SUBWAY TV MEDIA SYSTEM

UNITED STATES PATENT AND TRADEMARK OFFICE

Figure 2 of Minesaki

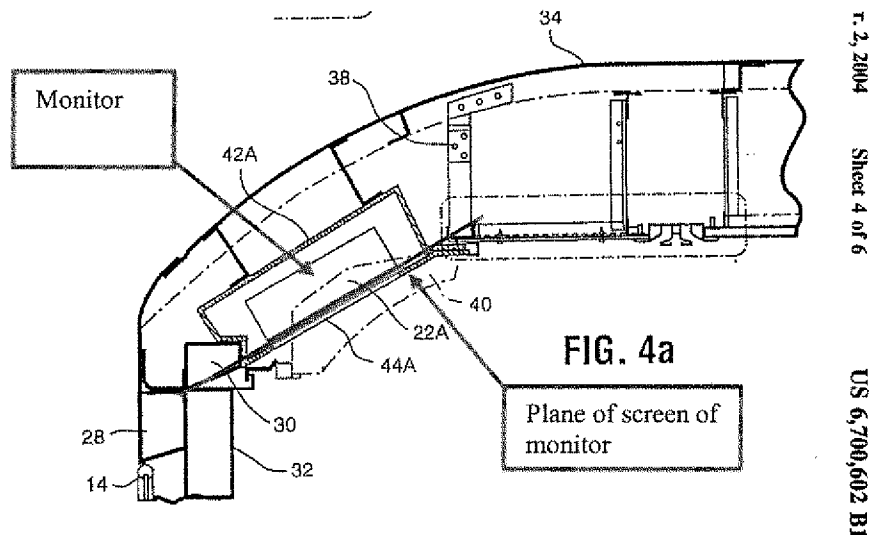
As can be seen, there is not a single part of the information transmission display (part J) illustrated in Figure 2 which can reasonably be considered to be flush with the adjacent wall surface (as Patent Owner has used that term in its specification and Claim 1); in fact, the entire information

transmission display part J of Minesaki clearly protrudes away from the adjacent wall surface. Patent Owner refers the Office to FIG. 4a of its specification (reproduced below for convenience), which clearly shows an embodiment of Patent Owner's invention that has a screen that is substantially flushed with the adjacent wall surface (as explicitly recited in Claim 1), and with no protrusion of the display (as occurs in Minesaki). As indicated in Patent Owner's specification regarding FIG. 4a, this configuration gives a better aesthetic appearance to the inside of the subway car as a whole, as well as improving the display performance by minimizing the interference effects.

Figure 2 of Maekawa

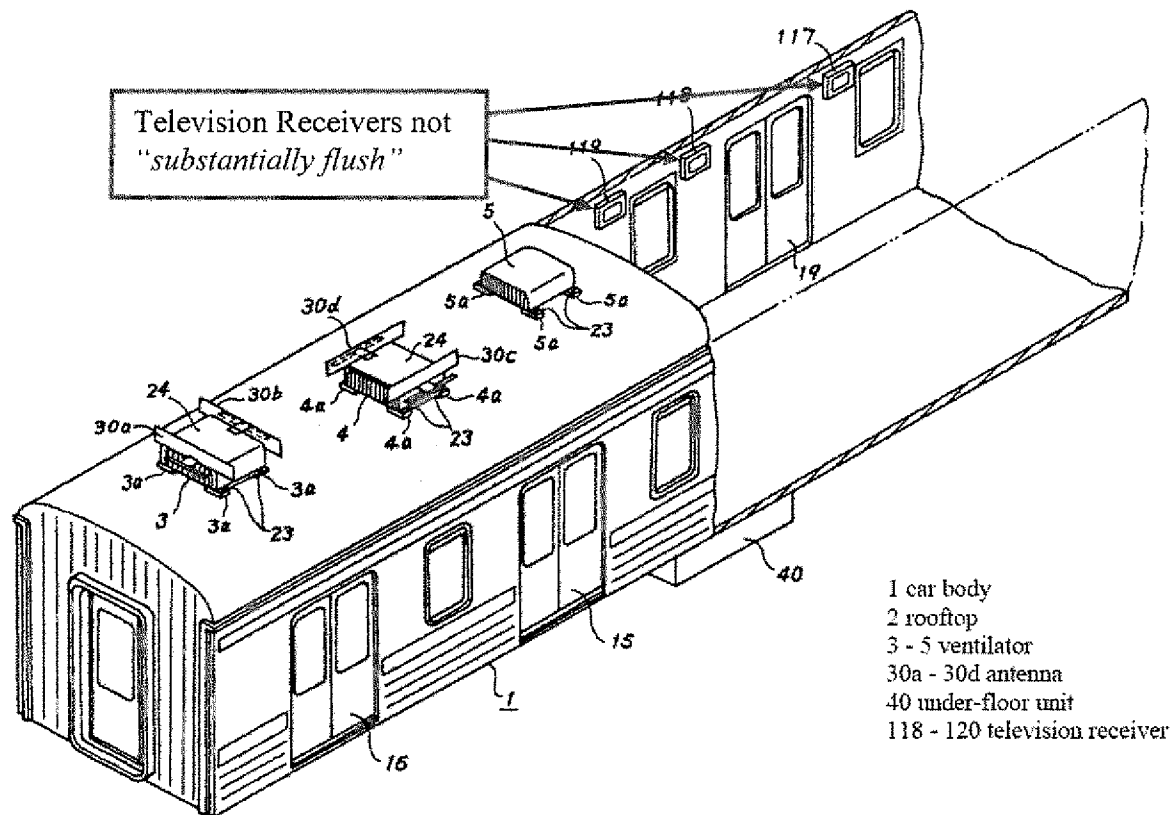
As can be seen, there is not a single part of the television receiver illustrated in Figure 2 (including especially its screen) that is flush with the adjacent wall surface structure of the car; in fact, the entire television receiver of Maekawa clearly protrudes from the adjacent car wall surface. Accordingly, Patent Owner respectfully submits that the Office's interpretation of the term "substantially flushed" is improper, as the Office's interpretation completely reads out the "flushed" feature.

Figure 4 of Amano

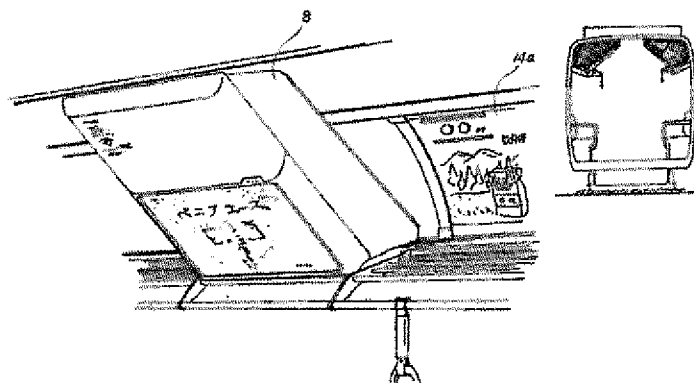
10 In the instant case, Amano fails to teach or suggest "the screen of the monitor [being] substantially flushed with the adjacent wall surface structure of the car". However, the Office states that the monitor of Amano can readily and predictably be substituted with the flush monitor of Moore. To the contrary, Patent Owner respectfully submits that the wall structure of Amano (in particular, the area near the junction of the sidewall and ceiling) would need to be appreciably modified in order to accommodate a flush monitor. See also, for example, FIG. 4a
15 of the '602 Patent. However, Amano also illustrates storage areas on the upper areas of the train. See for example, Figure 4 of Amano reproduced below.

20 Accordingly, modifications to the area near the junction of the sidewall and ceiling of the Amano train would render the Amano train unsatisfactory for its intended purpose. For example, if the wall surface structure near the information display device 8 were to be extended so that the screen of the information display device 8 were "substantially flushed" with its adjacent walls, the storage areas would need to be substantially reduced in size or eliminated entirely. It

Minesaki further discloses such a configuration in the annotated Figure 2, as shown below

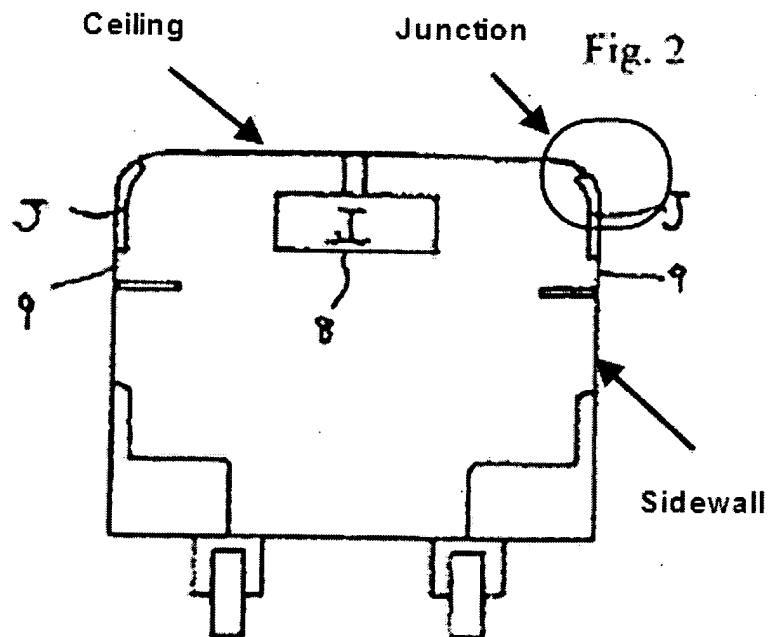
29. With respect to Owners reply/argument that Minesaki fails to expressly or inherently describe "each of said monitor being mounted at the junction of the sidewall and ceiling", the examiner respectfully disagrees. As Owner has noted, Minesaki discloses

This information transmission display part J may also be formed on the sidewall of the train car (page 590, right upper most column).

Minesaki further discloses such a configuration in the annotated Figure 2, as shown below

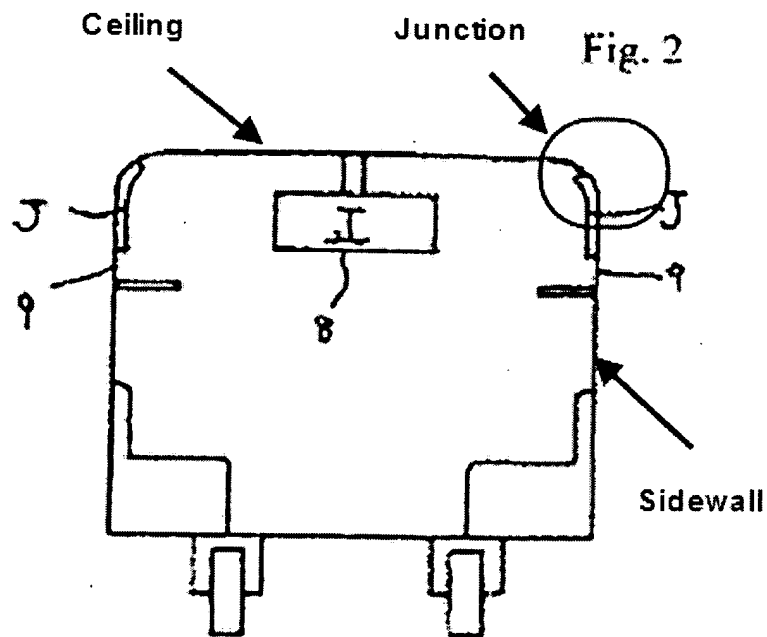
34. With respect to Owners reply/argument that Minesaki fails to expressly or inherently describe "each of said monitor being mounted at the junction of the sidewall and ceiling", the examiner respectfully disagrees. As Owner has noted, Minesaki discloses

In the annotated Figure 2 above, Minesaki illustrates a ceiling portion, a sidewall portion, and a junction portion between the respective sidewall and ceiling portions (see

Figure 2 of Maekawa

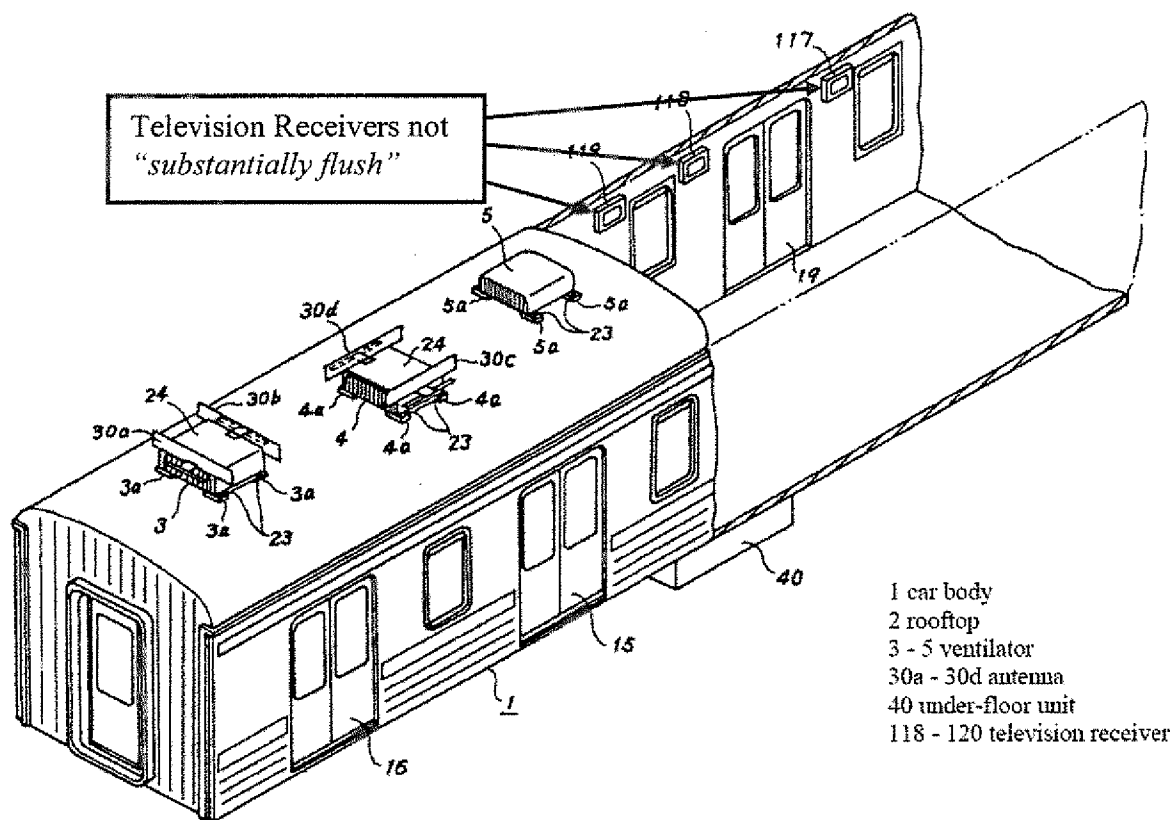
As can be seen, there is not a single part of the television receiver illustrated in Figure 2 (including especially its screen) that is flush with the adjacent wall surface structure of the car; in fact, the entire television receiver of Maekawa clearly protrudes from the adjacent car wall surface. Accordingly, Patent Owner respectfully submits that the Office's interpretation of the term "substantially flushed" is improper, as the Office's interpretation completely reads out the "flushed" feature.

Figure 4 of Amano

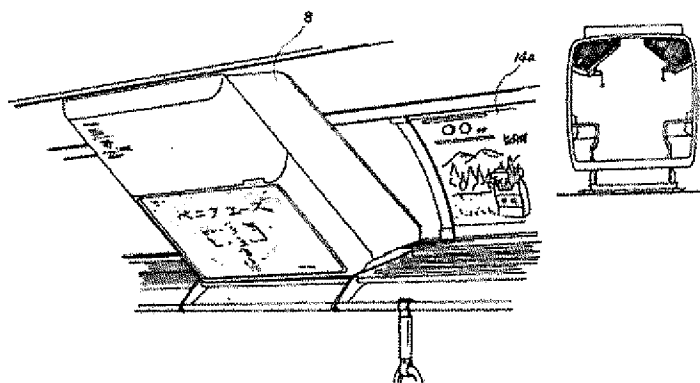
20 In the instant case, Amano fails to teach or suggest “*the screen of the monitor [being] substantially flushed with the adjacent wall surface structure of the car*”. However, the Office states that the monitor of Amano can readily and predictably be substituted with the flush monitor of Moore. To the contrary, Patent Owner respectfully submits that the wall structure of Amano (in particular, the area near the junction of the sidewall and ceiling) would need to be appreciably modified in order to accommodate a flush monitor. See also, for example, FIG. 4a of the ‘602 Patent. However, Amano also illustrates storage areas on the upper areas of the train. See for example, Figure 4 of Amano reproduced below.

Accordingly, modifications to the area near the junction of the sidewall and ceiling of the Amano train would render the Amano train unsatisfactory for its intended purpose. For example, if the wall surface structure near the information display device 8 were to be extended so that the screen of the information display device 8 were “substantially flushed” with its adjacent walls, the storage areas would need to be substantially reduced in size or eliminated entirely. It is not clear to Patent Owner why one would be motivated to make such a modification, where the modification would remove desirable storage area on the train of Amano, thereby leading to a situation where no overhead storage is available for passengers’ luggage or other items. By analogy, one would not design a commercial airliner such that no overhead storage was available (thereby requiring passengers to check all baggage).

Minesaki further discloses such a configuration in the annotated Figure 2, as shown below

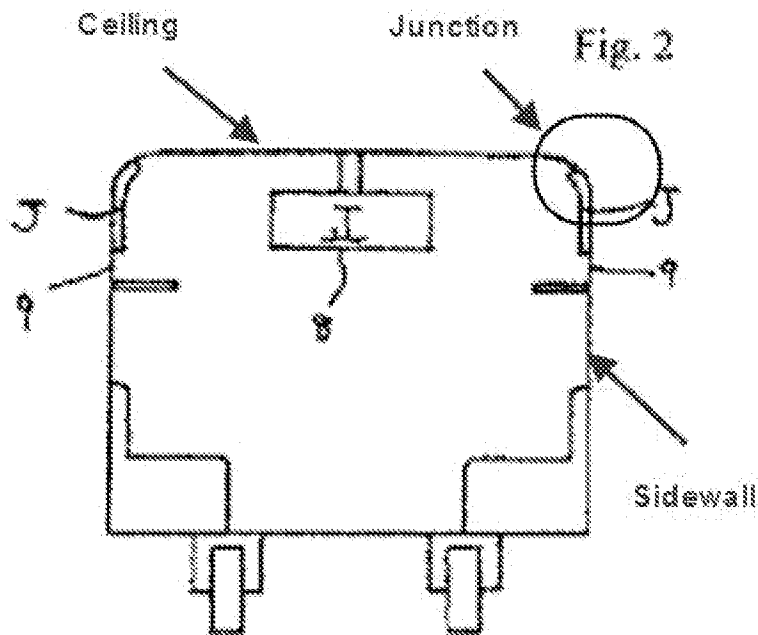
With respect to Owners reply/argument that Minesaki fails to expressly or inherently describe “each of said monitor being mounted at the junction of the sidewall and ceiling”, the examiner respectfully disagrees. As Owner has noted, Minesaki discloses

In the annotated Figure 2 above, Minesaki illustrates a ceiling portion, a sidewall portion, and a junction portion between the respective sidewall and ceiling portions (see above). In addition, the monitor (information transmission display part **J**) is clearly partially mounted and disposed in the junction portion between the respective sidewall and ceiling portions. Therefore, Minesaki fully meets “each of said monitor being mounted at the junction of the sidewall and ceiling” given its broadest reasonable interpretation.

Minesaki further discloses such a configuration in the annotated Figure 2, as shown below

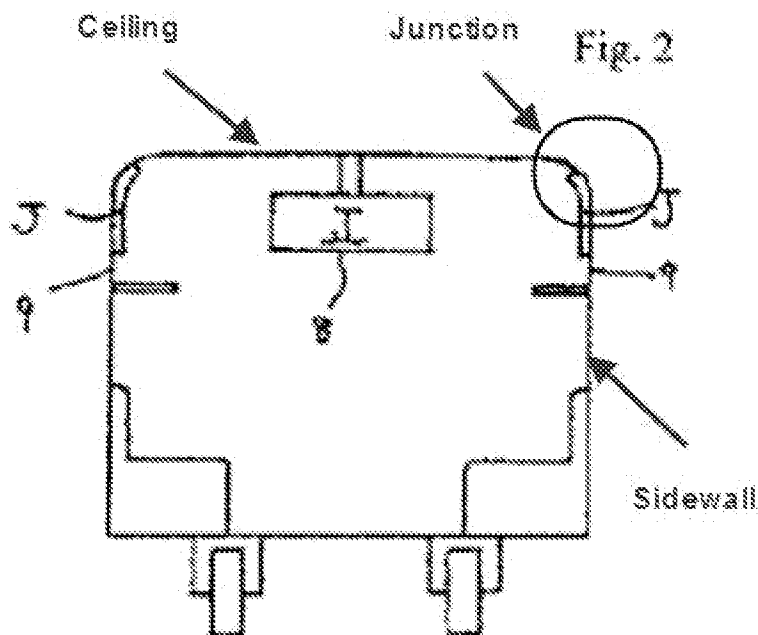
With respect to Owners reply/argument that Minesaki fails to expressly or inherently describe “each of said monitor being mounted at the junction of the sidewall and ceiling”, the examiner respectfully disagrees. As Owner has noted, Minesaki discloses

In the annotated Figure 2 above, Minesaki illustrates a ceiling portion, a sidewall portion, and a junction portion between the respective sidewall and ceiling portions (see

Figure 2 of Minesaki

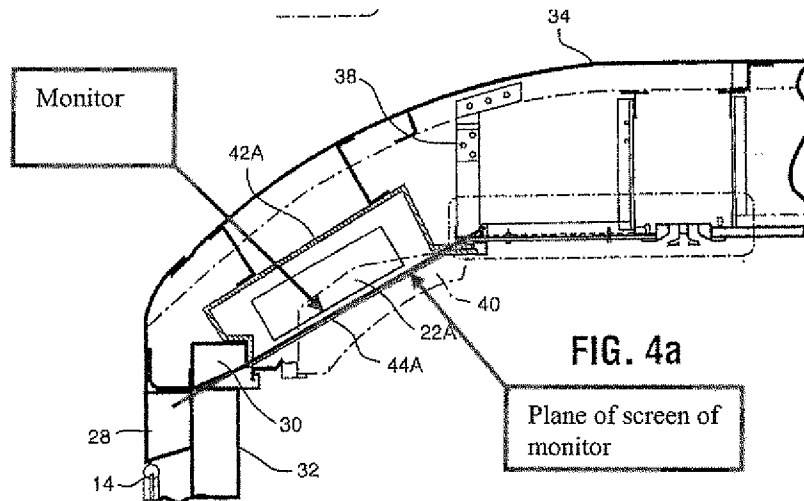
As can be seen, there is not a single part of the information transmission display (part J) illustrated in Fig. 2 which can reasonably be considered to be flush with the adjacent wall surface (as Patent Owner has used that term in its specification and Claim 1); in fact, the entire information transmission display part J of Minesaki clearly protrudes away from the adjacent wall surface. Patent Owner refers the Office to FIG. 4a of its specification (reproduced below for convenience), which clearly shows an embodiment of Patent Owner’s invention that has a screen that is substantially flushed with the adjacent wall surface (as explicitly recited in Claim 1), and with no protrusion of the display (as occurs in Minesaki). As indicated in Patent Owner’s specification regarding FIG. 4a, (See, e.g. Col 5, lines 42 – 45 of Patent Owner’s specification) this configuration gives a better aesthetic appearance to the inside of the subway car as a whole, as well as improving the display performance by minimizing the interference effects.

Figure 2 of Maekawa

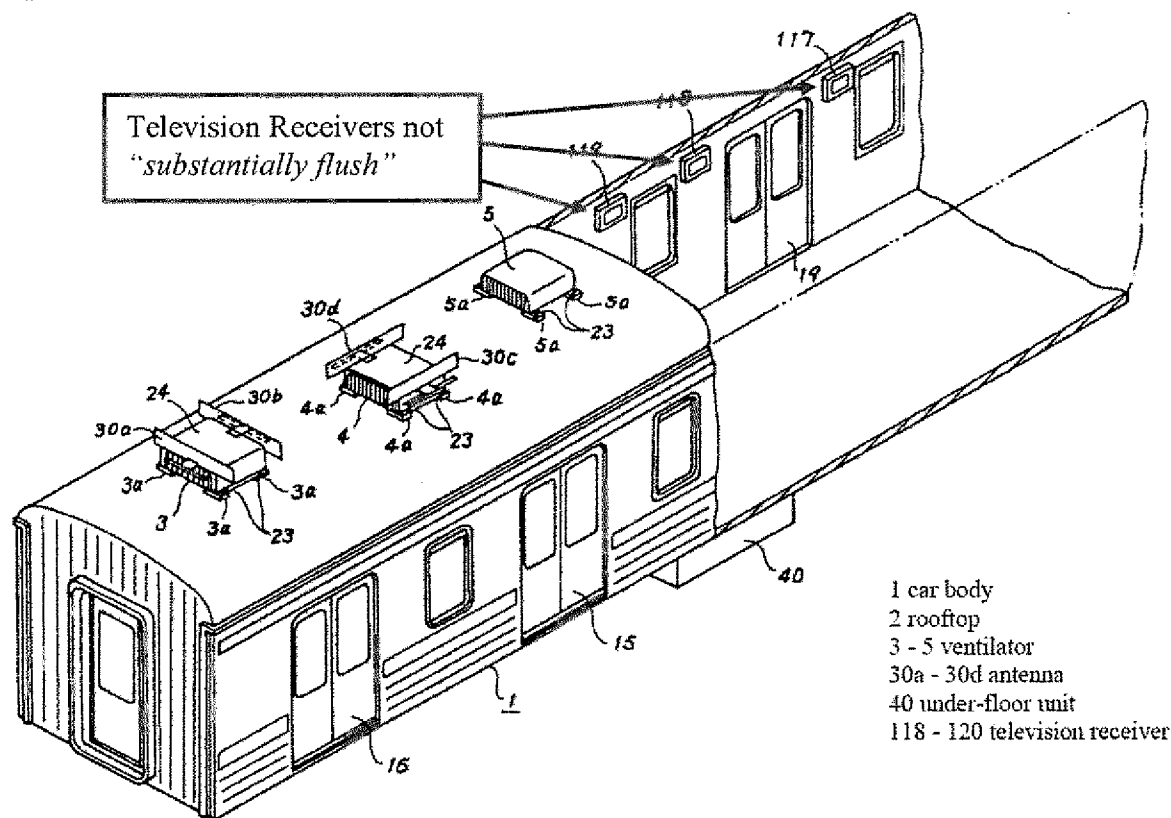
As can be seen, there is not a single part of the television receiver illustrated in Figure 2 (including especially its screen) that is flush with the adjacent wall surface structure of the car; in fact, the entire television receiver of Maekawa clearly protrudes from the adjacent car wall surface, or sits on top of the adjacent wall surface, by an amount roughly equal to the thickness of the wall itself. Accordingly, Patent Owner respectfully submits that the Office’s interpretation of the term “substantially flushed” is improper, as the Office’s interpretation completely reads out the “flushed” feature.

Figure 4 of Amano

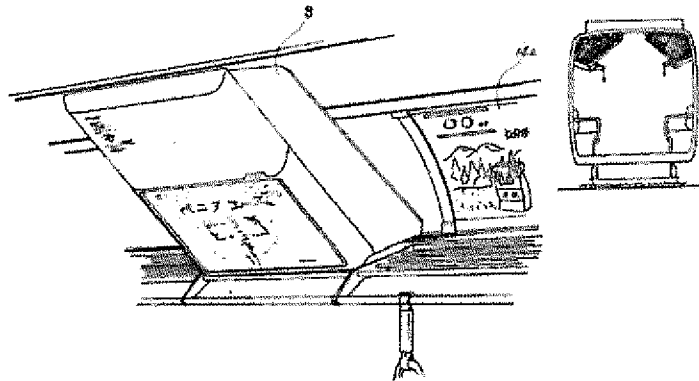
In the instant case, Amano fails to teach or suggest “the screen of the monitor [being] substantially flushed with the adjacent wall surface structure of the car”. However, the Office states that the monitor of Amano can readily and predictably be substituted with the flush monitor of Moore. To the contrary, Patent Owner respectfully submits that the wall structure of Amano (in particular, the area near the junction of the sidewall and ceiling) would need to be appreciably modified in order to accommodate a flush monitor. See also, for example, FIG. 4a of the ‘602 Patent. However, Amano also illustrates storage areas on the upper areas of the train. See for example, Figure 4 of Amano reproduced below.

Accordingly, modifications to the area near the junction of the sidewall and ceiling of the Amano train would render the Amano train unsatisfactory for its intended purpose. For example, if the wall surface structure near the information display device 8 were to be extended so that the screen of the information display device 8 were “substantially flushed” with its adjacent walls, the storage areas would need to be substantially reduced in size or eliminated entirely. It is not clear to Patent Owner why one would be motivated to make such a modification, where the modification would remove desirable storage area on the train of Amano, thereby leading to a situation where no overhead storage is available for passengers’ luggage or other items. By analogy, one would not design a commercial airliner such that no overhead storage was available (thereby requiring passengers to check all baggage).

Issue 1: Rejection of Claim 1 under 35 under 35 U.S.C. 102 as Being Anticipated by Minesaki

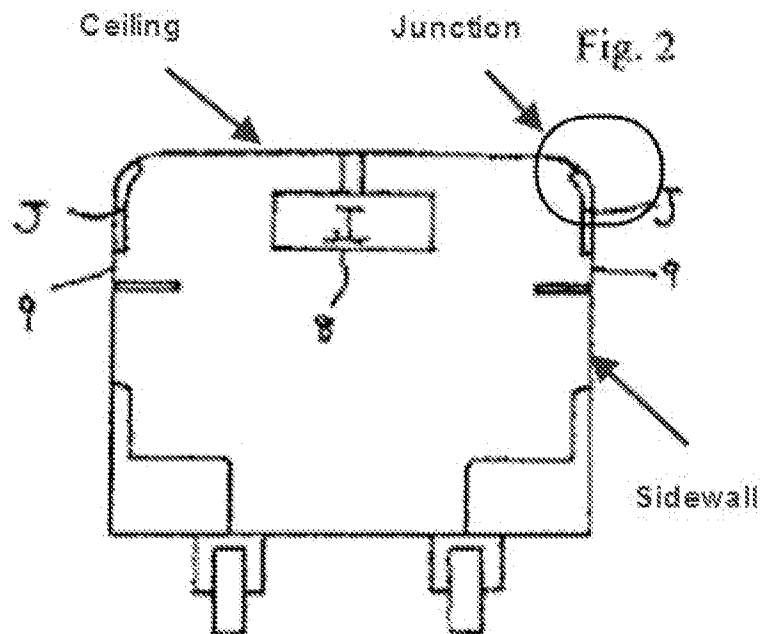
With respect to Appellant's reply/argument that Minesaki fails to expressly or inherently describe "each of said monitor being mounted at the junction of the sidewall
